**Date:** December 19, 2019

**To:** Chris Budai, U.S. Army Corps of Engineers

**From:** Jennifer Peterson, Mike Poulsen, Bob Schwarz - DEQ

**Subject:** Bradford Island, ECSI # 2010; Review of draft *Quality Assurance Project Plan for Passive Sampling at River Operable Unit*

**Figure 1: River Operable Unit Source Areas of Interest Offshore of Sandblast Area**

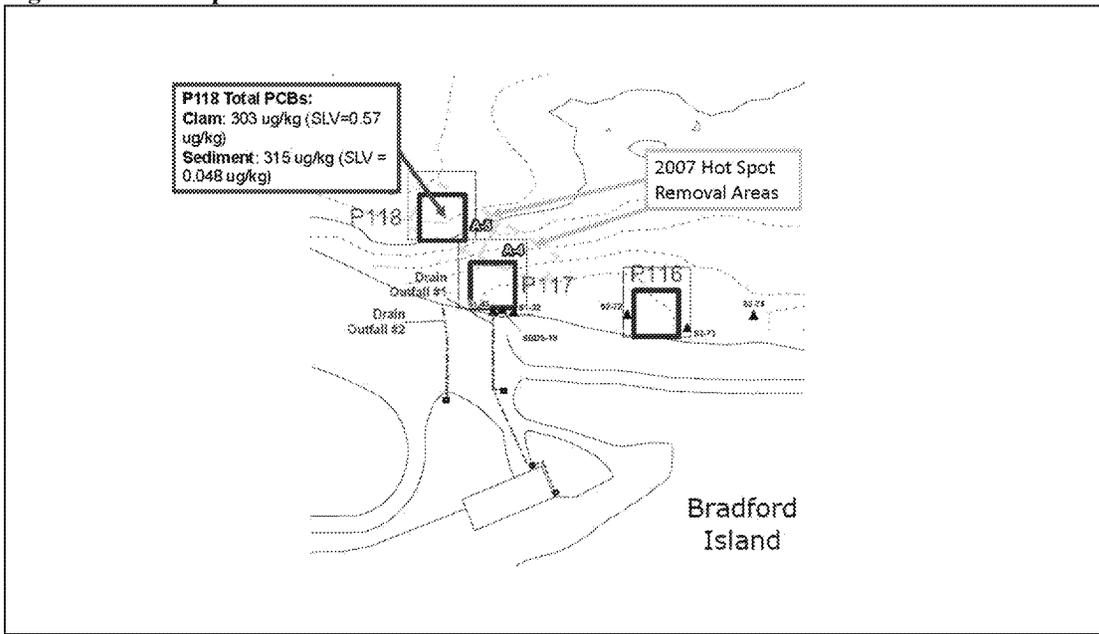
**Section 2.1.3, Sample Station Selection [and Appendix C, Bradford Island Sampling Location Figures].** It would have been helpful if the sandblast area outfalls had been shown on the sample location maps provided in Appendix C. From what we can tell from the figures, the location of previous sediment sample P118 may be outside of the initial sample points, although it appears to be covered by contingency points north of Outfall #2. The omission of passive samples offshore of the outfall would be a significant data

gap in this passive sampling design, and would limit our ability to draw conclusions regarding the presence of source areas at Bradford Island.

Considering that a removal action occurred in this area in 2007, and subsequent traditional sediment and clam sampling was completed in 2012, it is not clear why the placement of passive samplers at those locations would not be feasible. This is an area of historical contamination, and sediment from a hot spot in this area was removed as a part of the 2007 remedial action. Based on concentrations detected in sediment and clams in 2012, this area is still an area of concern due to elevated concentrations of total PCBs. In sample location P118, sediment concentrations were 315 ppb, and concentrations in clams were 303 ppb (see Figure 1 below). This area would meet the criteria outlined in this section.
